**Re: Design Notification 12 - Air Monitoring Frequency****Michael Berkoff** to: McGuire, Pat

**DESIGN NOTIFICATION NO. 2011-012**

**PROJECT:** Willow Boulevard Landfill Construction  
**SITE:** Allied Paper, Inc./Portage Creek/Kalamazoo River Superfund Site  
**LOCATION:** Kalamazoo, MI  
**OWNER:** Georgia-Pacific LLC  
**CONTRACTOR:** Terra Contracting  
**ENGINEER:** ARCADIS  
**COPIES TO:** Michael Berkoff (USEPA)  
Kristi Zakrzewski (MDNRE)  
Jeff Keiser (CH2M Hill)  
Scott Hutsell (CH2M Hill)  
Amanda Batts (CH2M Hill)  
Garry Griffith (Georgia-Pacific)  
Zachary Melda (Georgia-Pacific)  
Pat McGuire (ARCADIS)  
Bill Rankin (ARCADIS)  
EJ Suardini (ARCADIS)  
Phil Batten (ARCADIS)  
Danielle Amber (ARCADIS)

**Figure 1 Air Sampling Results at Willow Boulevard Landfill**

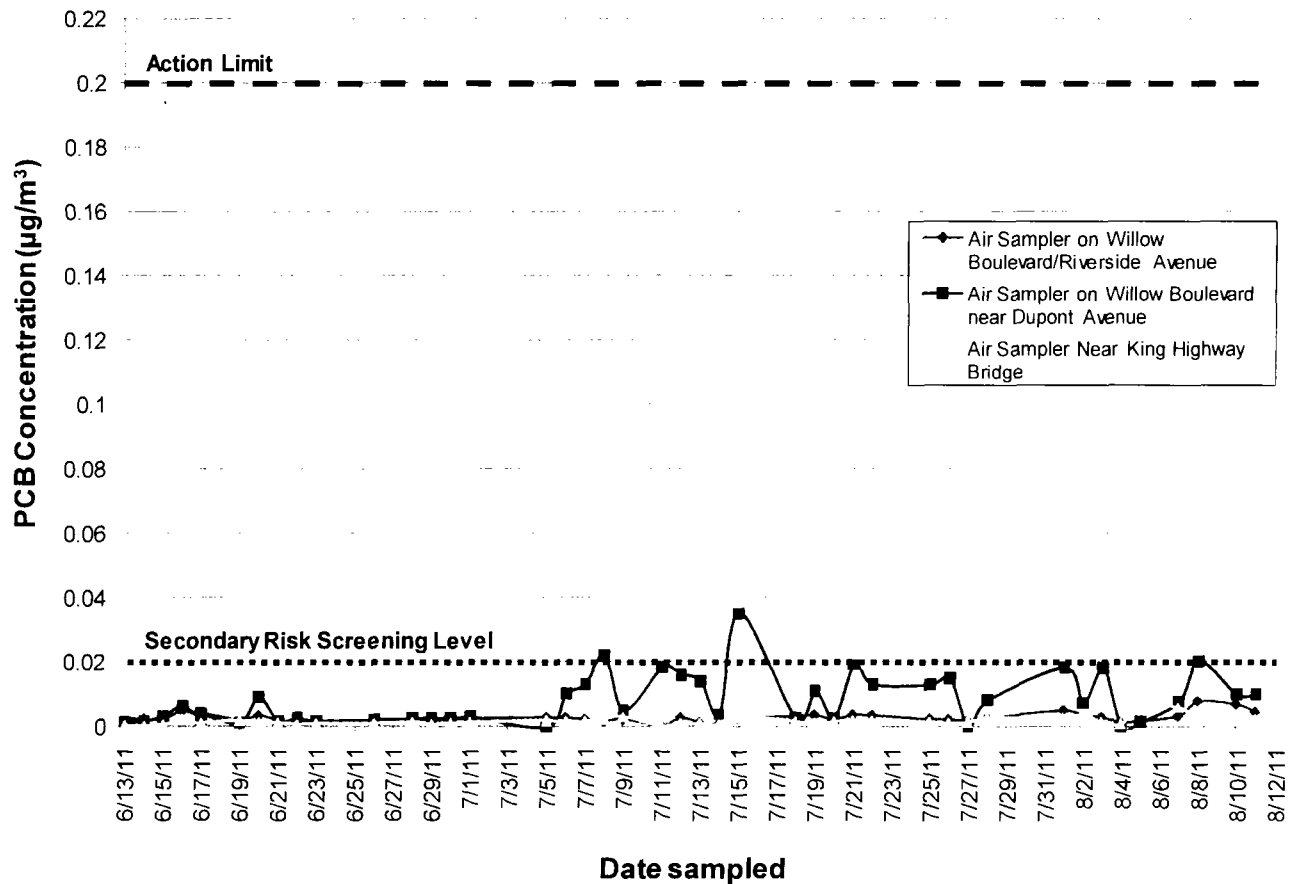
Ambient Air Monitoring, as described in the Remedial Design, prescribes three monitoring stations located around the perimeter of Willow Boulevard Landfill – one background and two located on the south property line. Each monitor collects air samples on a 24 hour basis, per sample, during excavation activities. The Remedial Design – Ambient Air Monitoring sets an action limit of  $0.2 \mu\text{g}/\text{m}^3$ . Since the onset of air monitoring activities approximately 132 air sample results have been received for the three air monitoring stations. To date, there have been no exceedances of this Action Limit (as indicated in Figure 1). Additionally, the air monitoring samples have shown the air PCB concentrations during excavation activities are (with three exceptions) below the Secondary Risk Screening Level (SRSL) of  $0.02 \mu\text{g}/\text{m}^3$ . Since there have been no exceedances of the PCB Action Limit to date, and only three results at or above the SRSL, a reduction in the sampling frequency at the Willow Boulevard Landfill is requested. The request is to reduce the sampling to a minimum frequency of one sample per week during

earthwork including grading /cover activities or during periods when dry and dusty conditions exist. Air sampling activities would be performed in consultation with USEPA oversight personnel. Once the sand gas venting layer has been placed over consolidated materials on the landfill, it is proposed that air monitoring activities will be discontinued. Real-time air monitoring will continue as previously.

If, at any point during reduced frequency sampling, the Action Limit is exceeded in any of the air samples, USEPA will be informed and daily air monitoring will be resumed until PCB concentrations again meet the performance criteria of  $0.2 \mu\text{g}/\text{m}^3$ .

Garry,  
 EPA has received Design Notification No. 2011-12 which is the request to reduce the frequency of air monitoring of PCBs at the Willow Boulevard/A-Site Operable Unit of the Allied Paper/Portage Creek/Kalamazoo River Superfund Site. After reviewing the notification, EPA approves it, allowing for the reduction of monitoring frequency to the levels proposed in Notification No. 2011-12. Please contact me if you have any questions.  
 Michael
